**Invitation to Bid
Welding Building Remodel
35-2015/2016**

PENSACOLA
STATE COLLEGE

Addendum #1

SHEET:
A-110

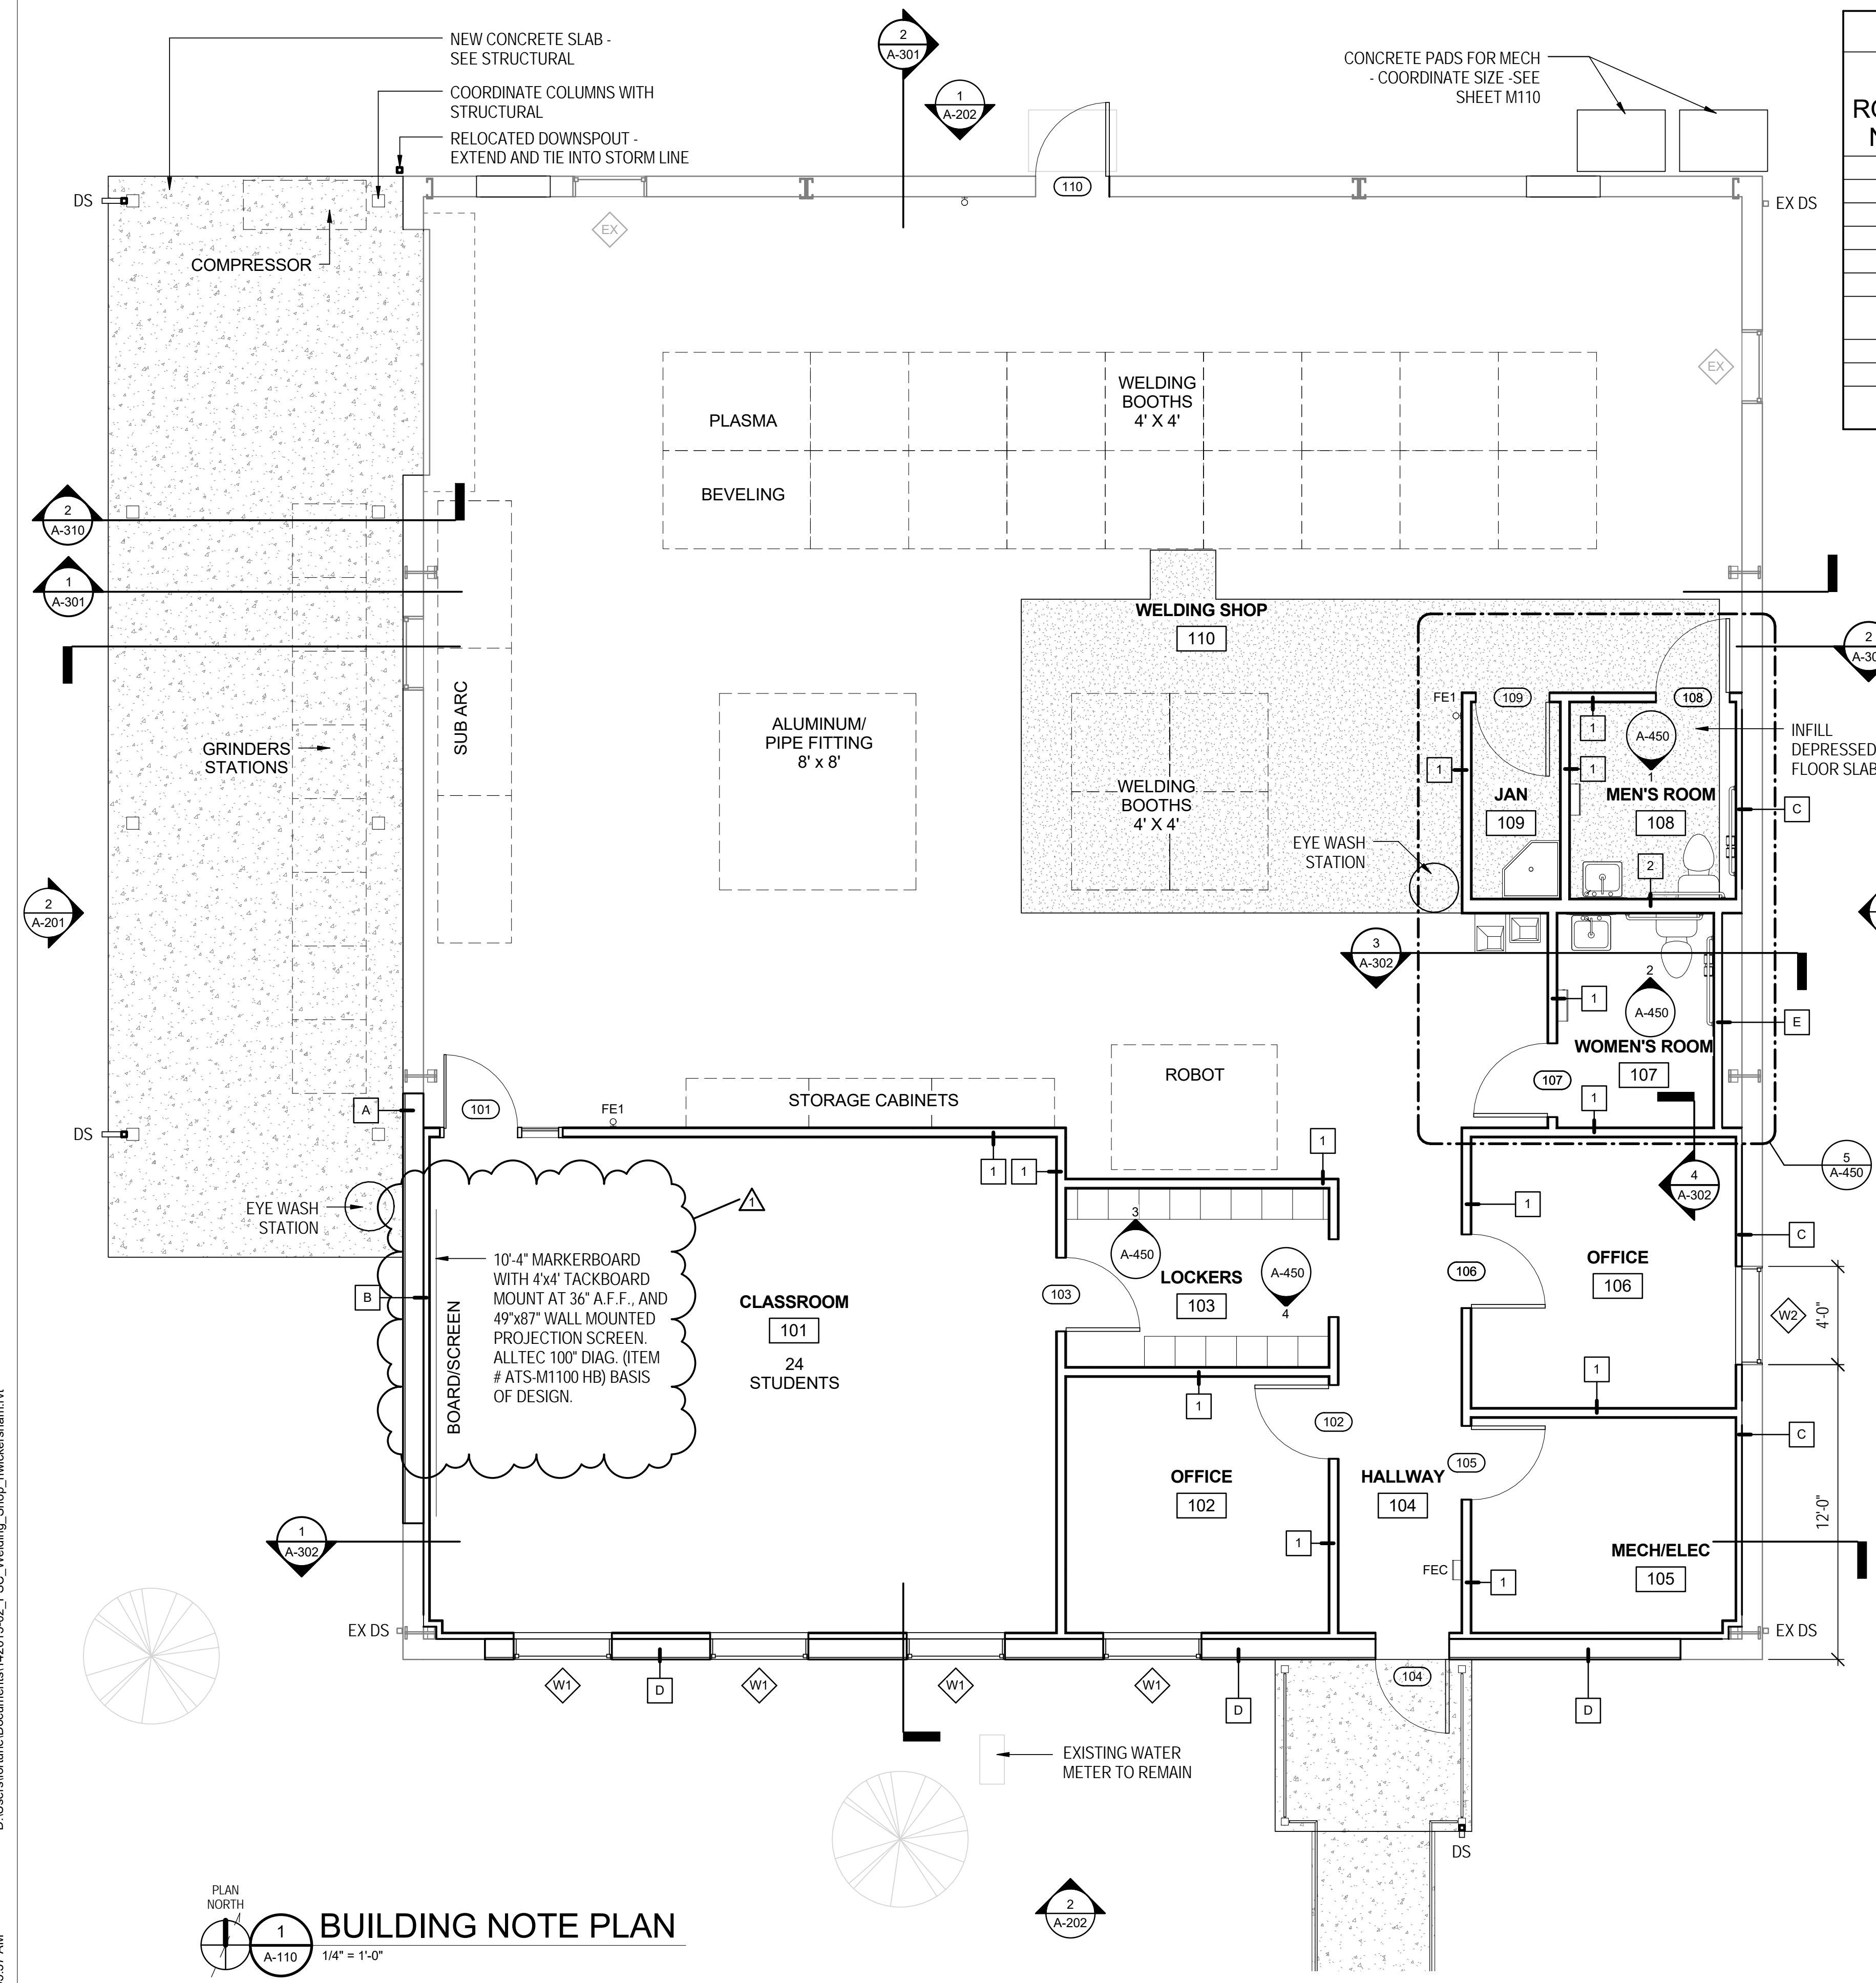
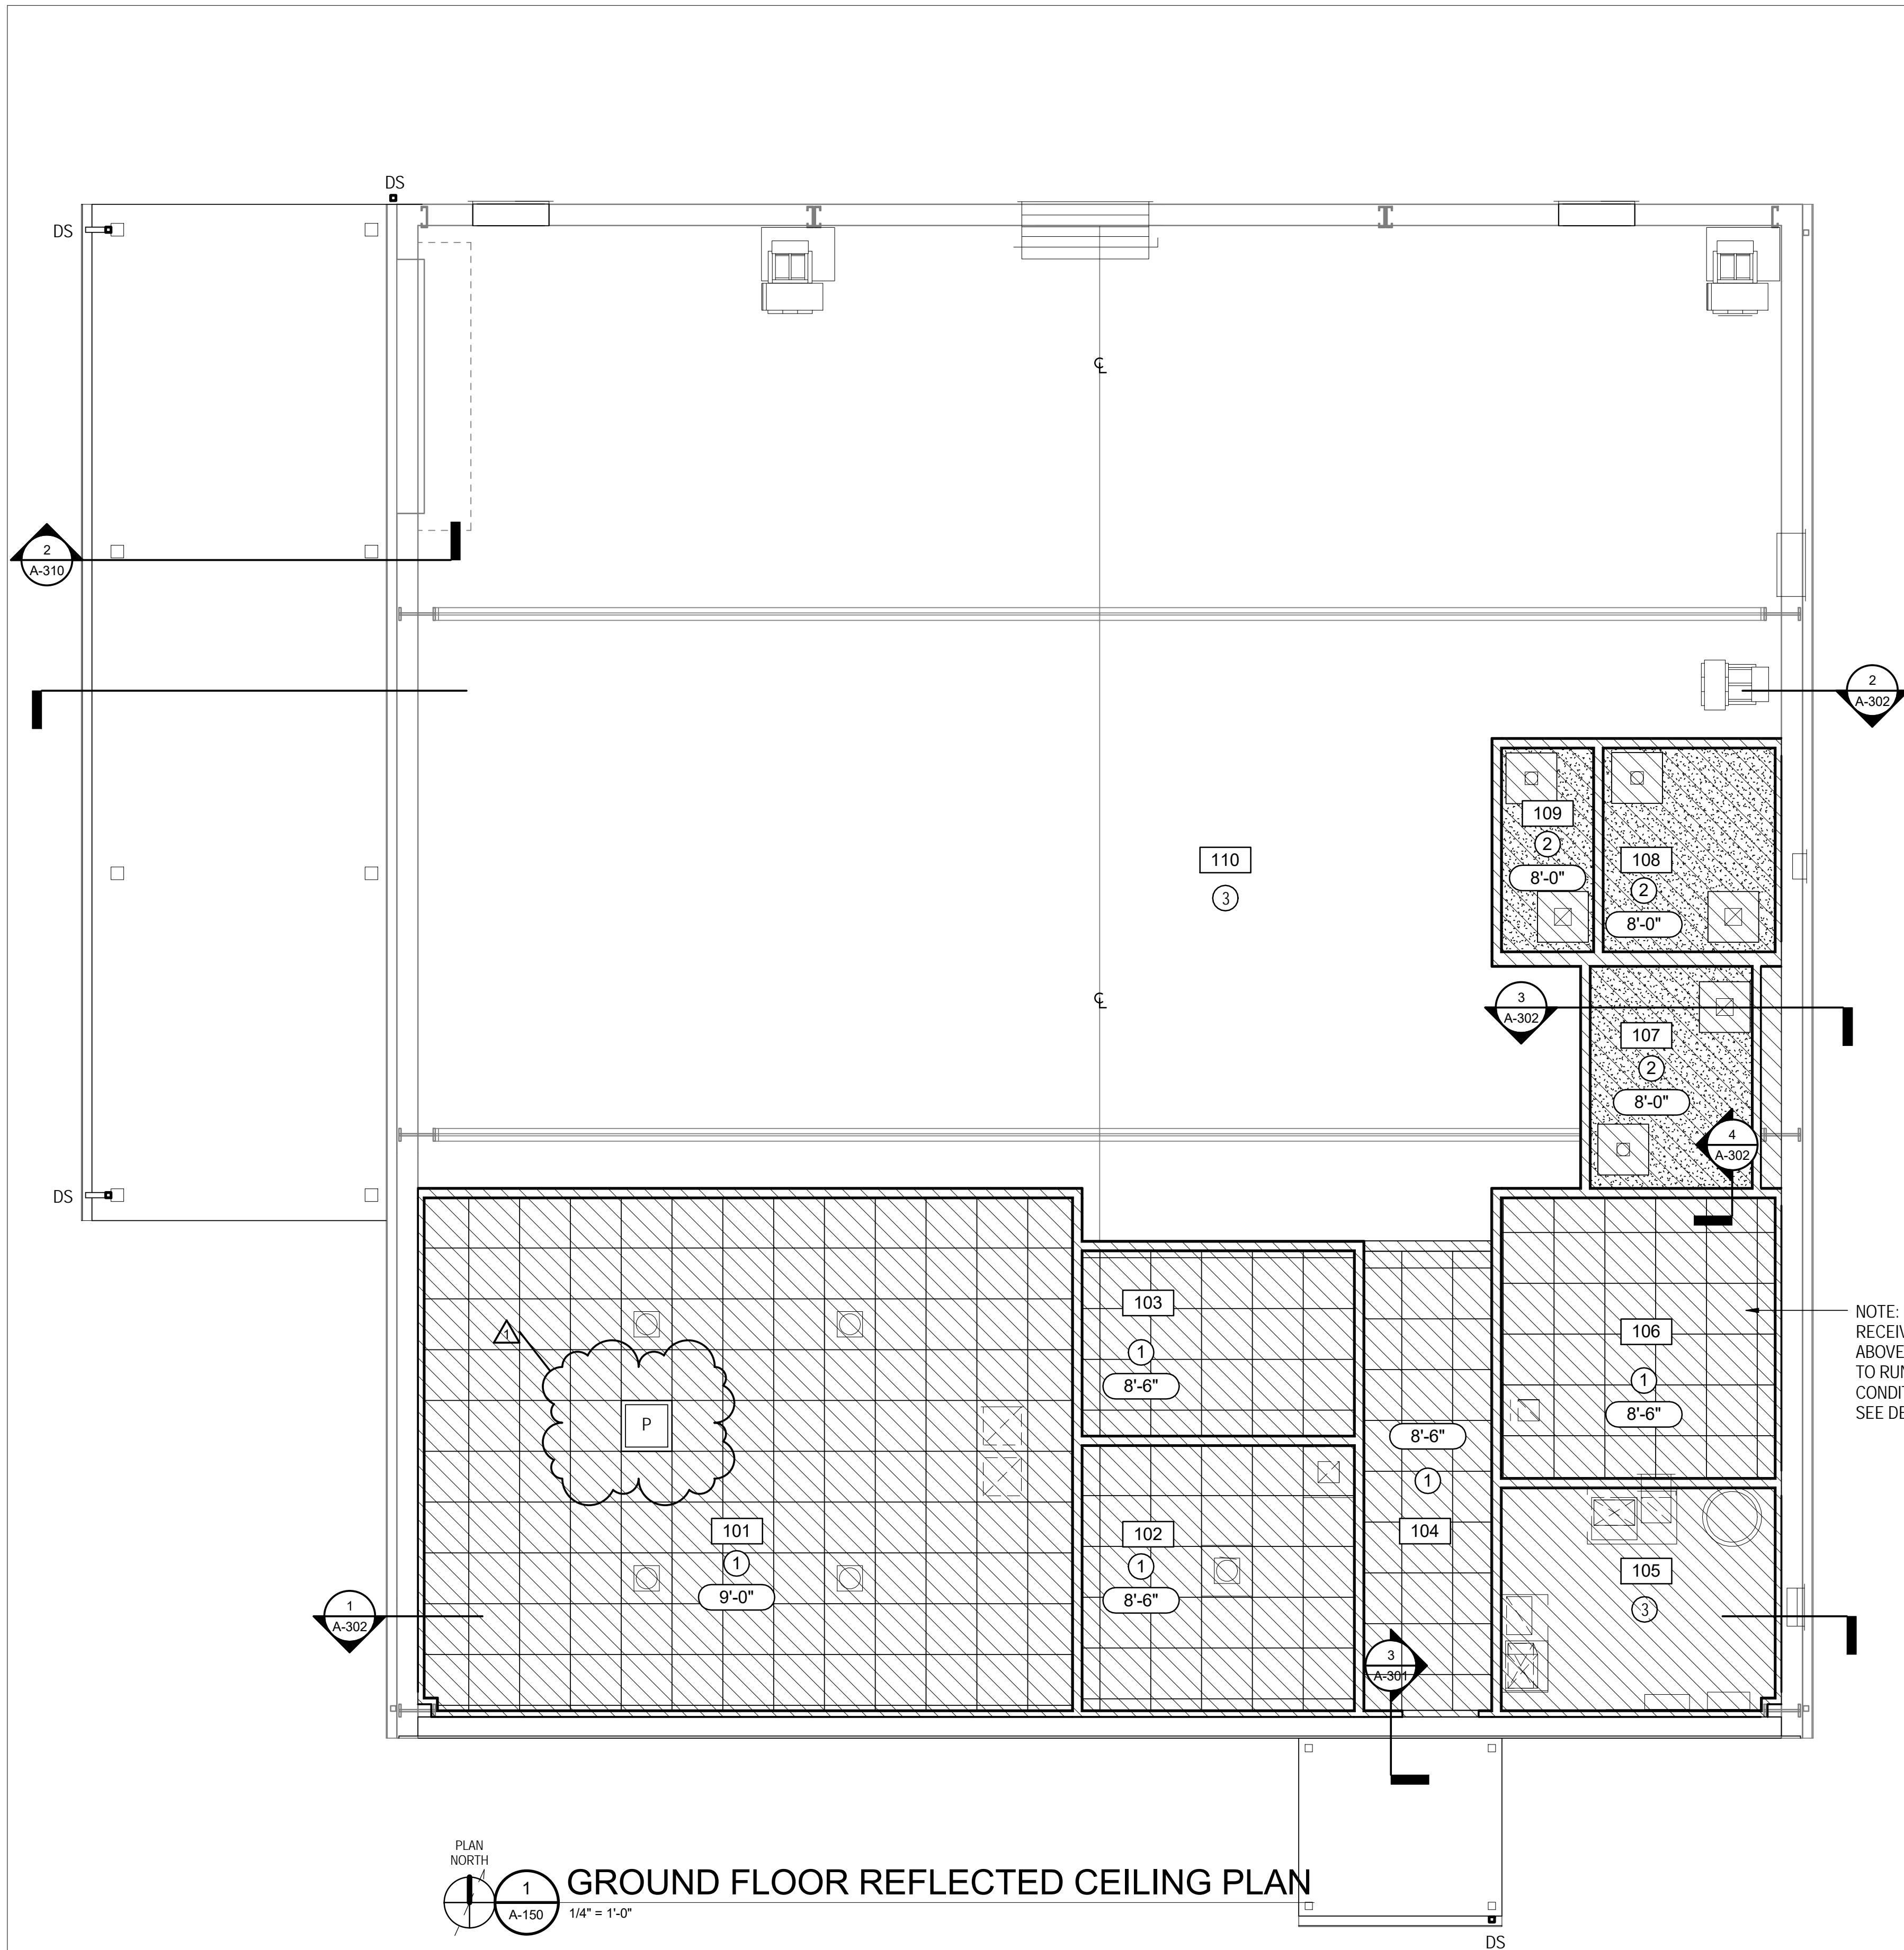
Question: Request: REFERENCE SHEETS A-110 AND A-601 REGARDING DOOR MARK 100. COMPLETE DOOR SCHEDULE.

Question: Request: REFERENCE SHEET A-110 (ROOM 101 AND GRAPHIC LEGEND). THE GRAPHIC LEGEND AND NOTES IN ROOM 101 INDICATE PROJECTION SCREEN. PROVIDE SPECIFICATIONS.

Response: Door 101 should match door 103. (There is no door 100).

Response: See revision attached for projection screen basis of design.

SHEET:
A-150

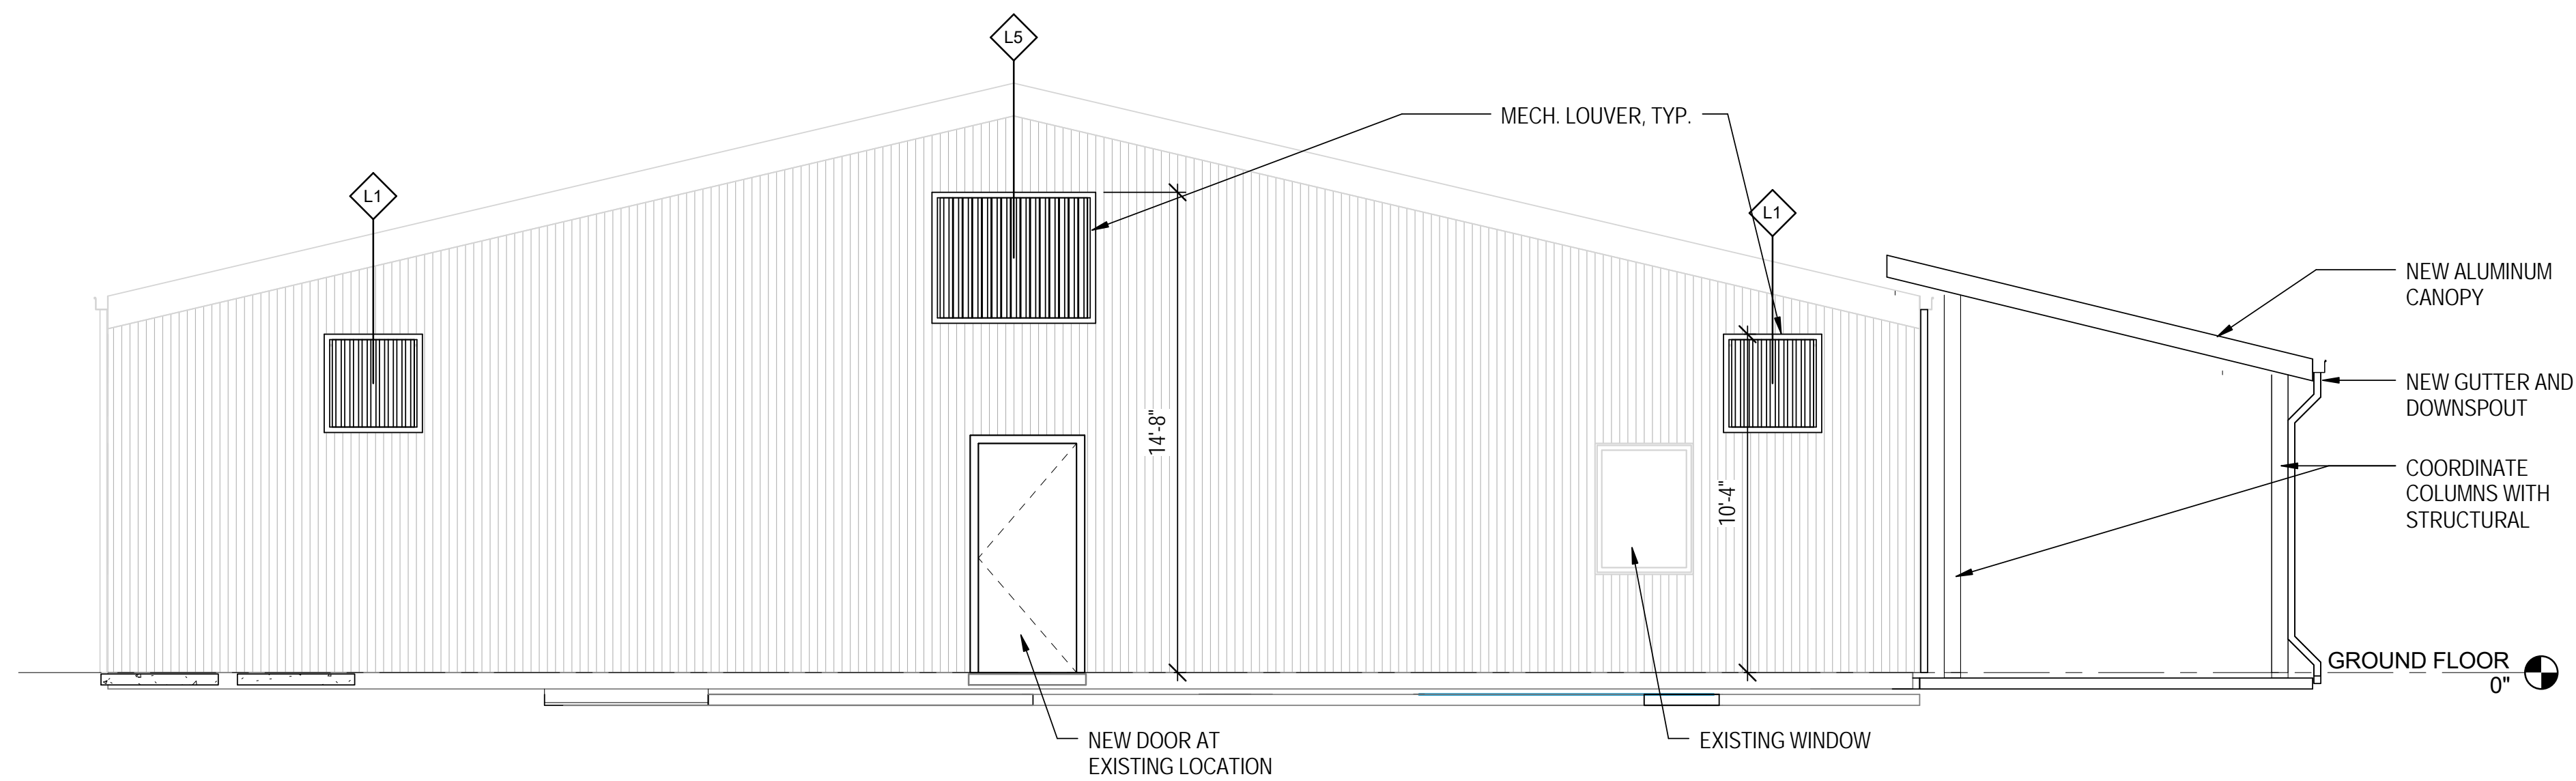
Question: What is the model of the Owner Furnished Projector?
Response: Owner furnished projector is Epson 99HW. Contractor to provide pan type projector mount, see revised reflected ceiling drawing.

SHEET:
E-104

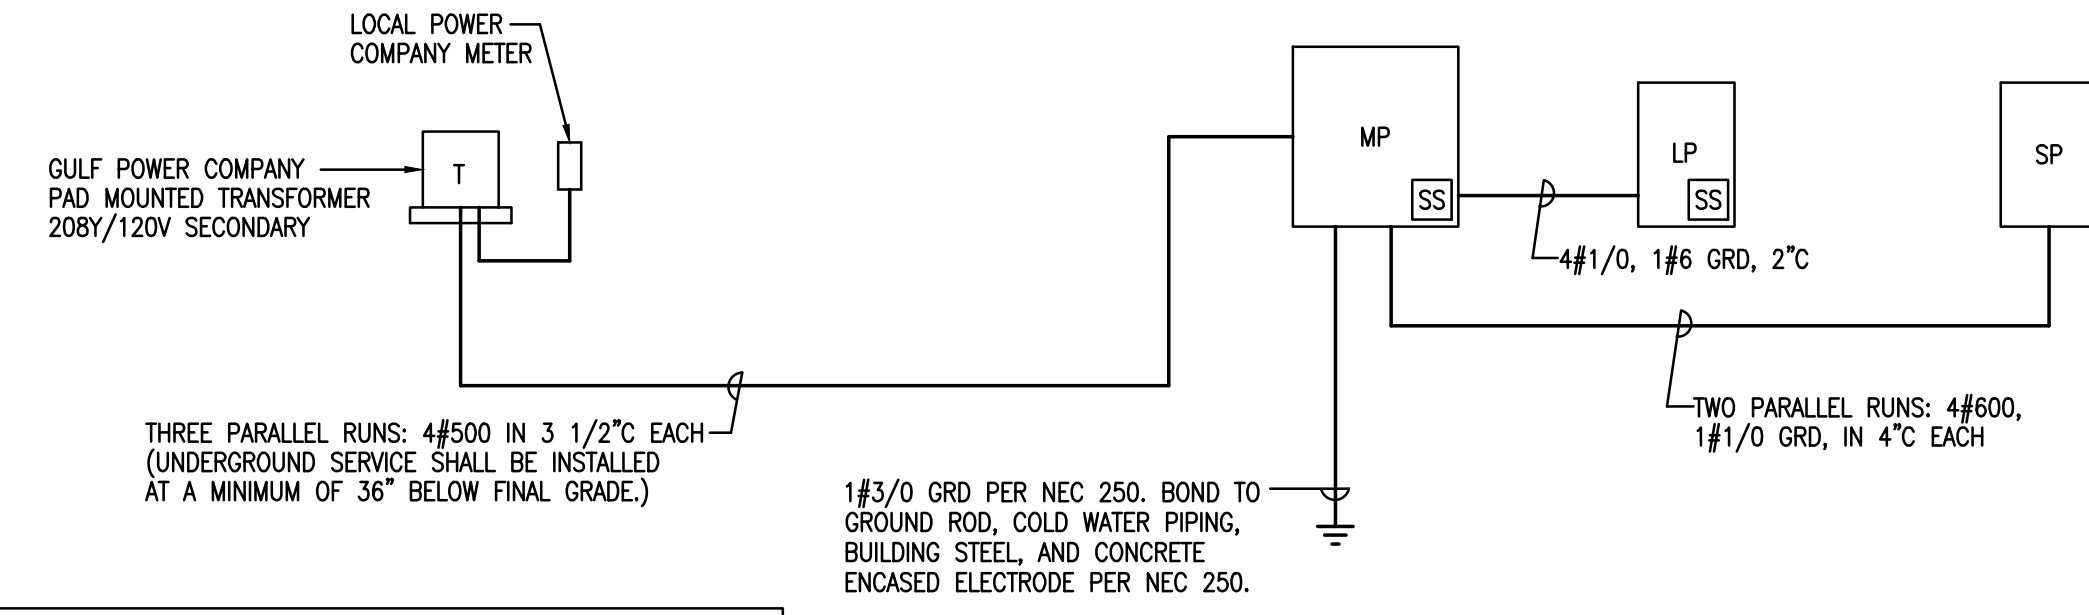
Question: Request: Date Required: REFERENCE SHEET E-104. THIS SHEET SHOWS A GULF POWER PAD MOUNTED TRANSFORMER. NO OTHER PAGES REFERENCE REPLACEMENT OF THE TRANSFORMER. CLARIFY.
Response: Location of transformer and all Gulf Power requirements including point of attachment, metering, transformer pad, etc shall be verified by the Contractor with Gulf Power. For bidding purposes, assume underground service length shall be 150' from padmounted transformer to main panel.
